Development Management Sub Committee

**Application for Listed Building Consent 18/02722/LBC
At Royal Hospital For Sick Children, 9 Sciennes Road,
Edinburgh**

Internal and external alteration to Category B-listed main hospital building to convert to residential use; removal of 20th century extensions, with associated fabric repairs and reinstatement; alteration to boundary wall to form public realm; alteration of former curtilage Pharmacy Store to convert to residential use.

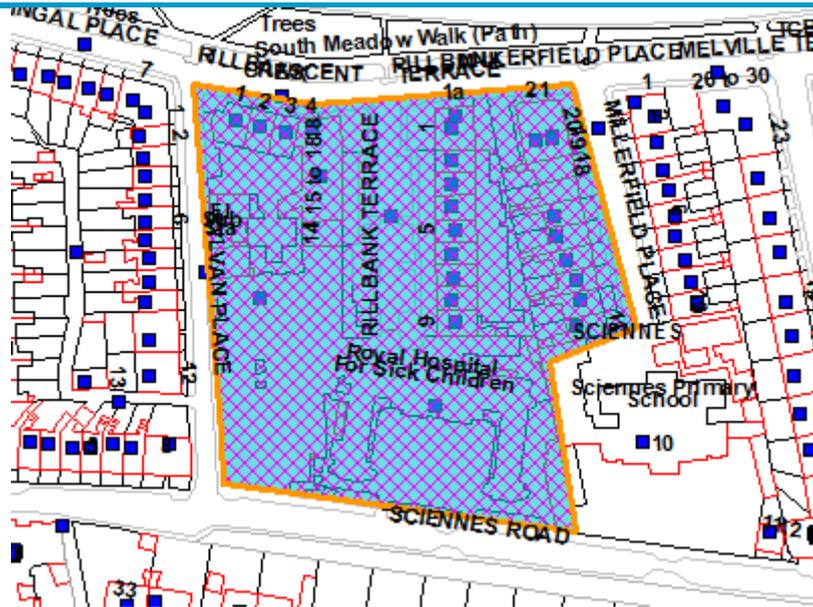
We would ask that the removal of the modern escape stair towers along with balustrade reinstatement to the octagonal towers (and main building) be included within the proposed works. Removal of the unsympathetic escape stair towers and reinstatement of the octagonal towers' missing parapets would significantly enhance the building's appearance (the design and access statement includes photographs showing the original appearance of the pavilion wings).

Whilst welcoming the proposed removal of the modern day lounge balcony infills facing Sciennes Road, the current proposal for replacement glazed balconies on the pavilions' south elevations should be reconsidered. The reflective quality of glazed balustrades in this location could in our view detract from the building's character. We would ask that a design solution, sympathetic to the hospital's bold Baroque style be developed. If it is not possible to reinstate the original form of the infill, (which would be most welcome) a more appropriate design could be adopted.
